**RE: Final Emergency Response Plan Design Report: 12th Street Landfill/Formal Powerhouse Channel,
Otsego Township, Michigan (Consent Decree, No. 1:05CV003)**

Response to USEPA Comments Emergency Response Plan Design Report 12th Street Landfill/Former Powerhouse Channel

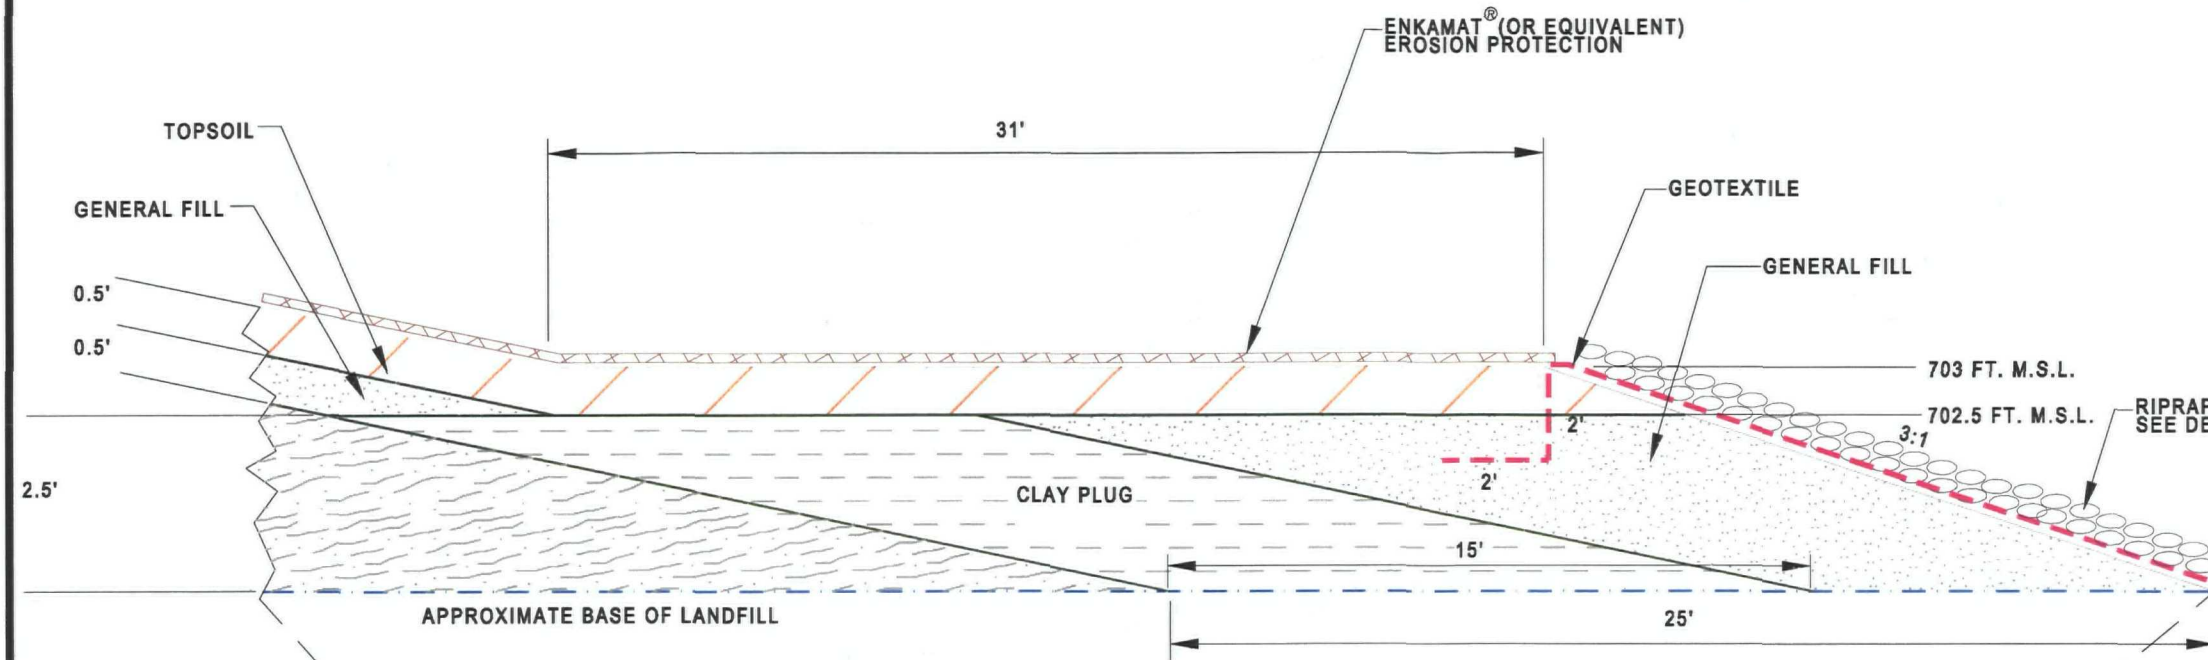
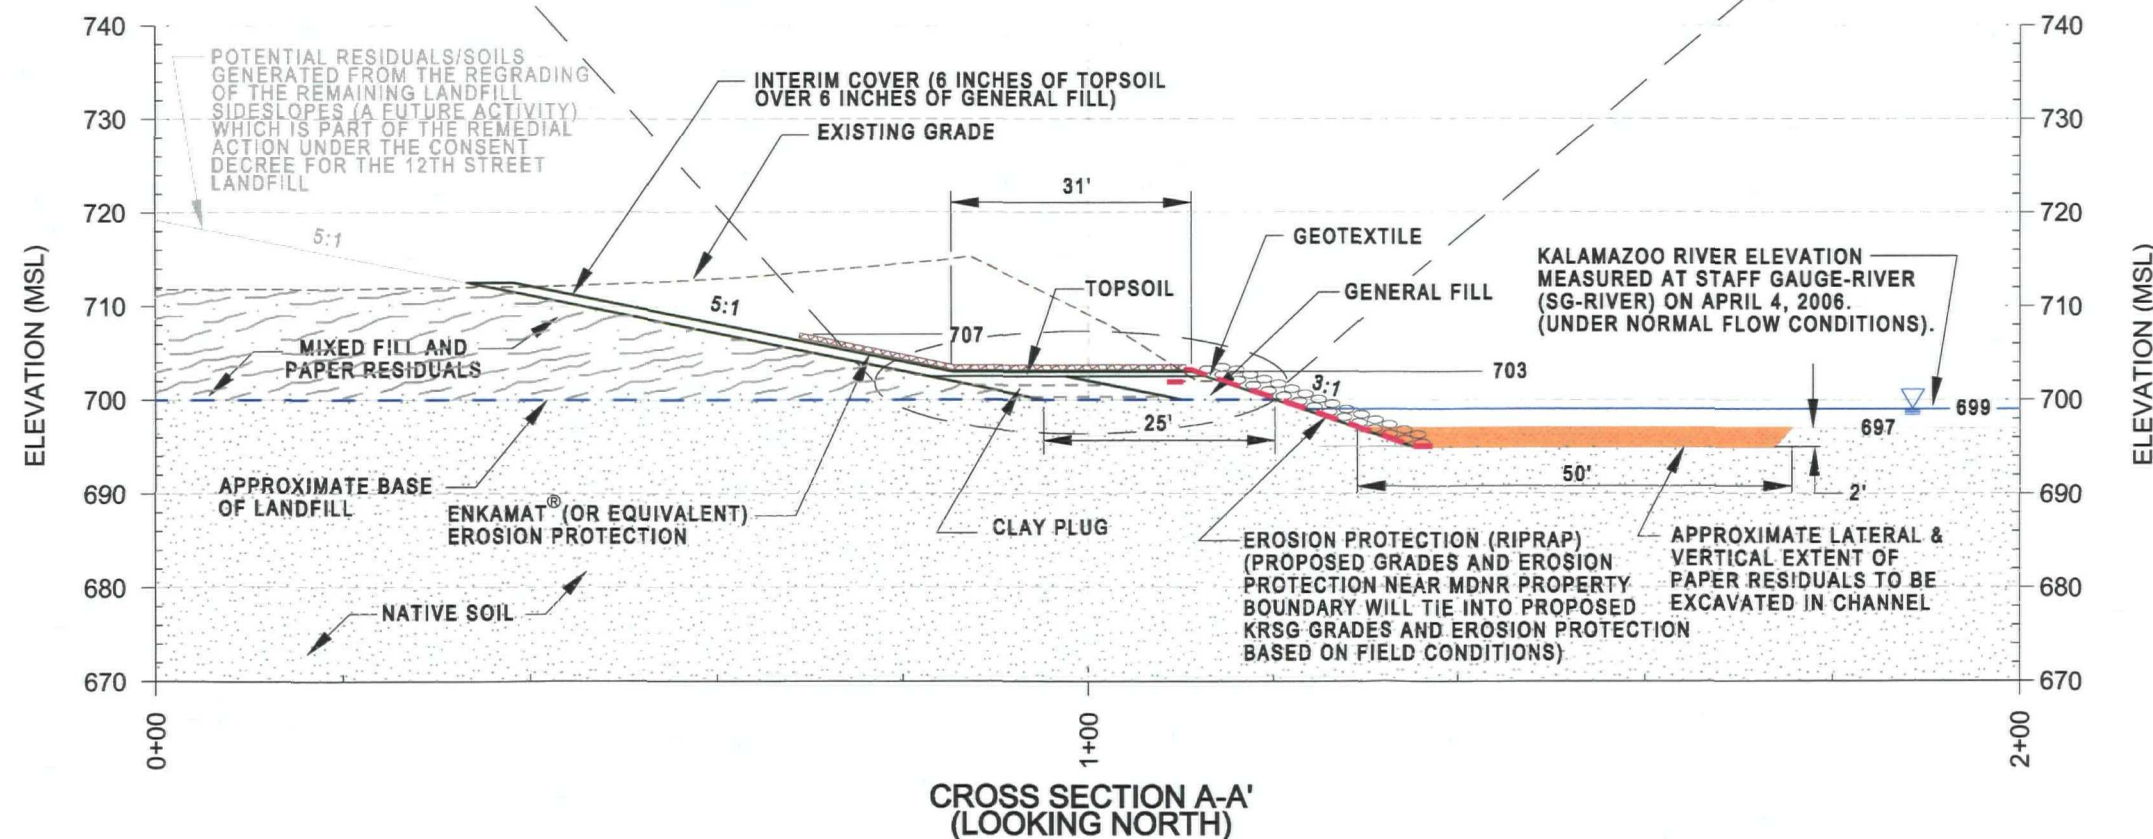
16. Figure 4 – The figure identifies a layer that would be comprised of residuals and soils. The figure label identifies this as a potential layer. In either the text of the document or as a note with in the figure, please identify the source for this potential layer. [Figure modified to further describe areas in question.](#)
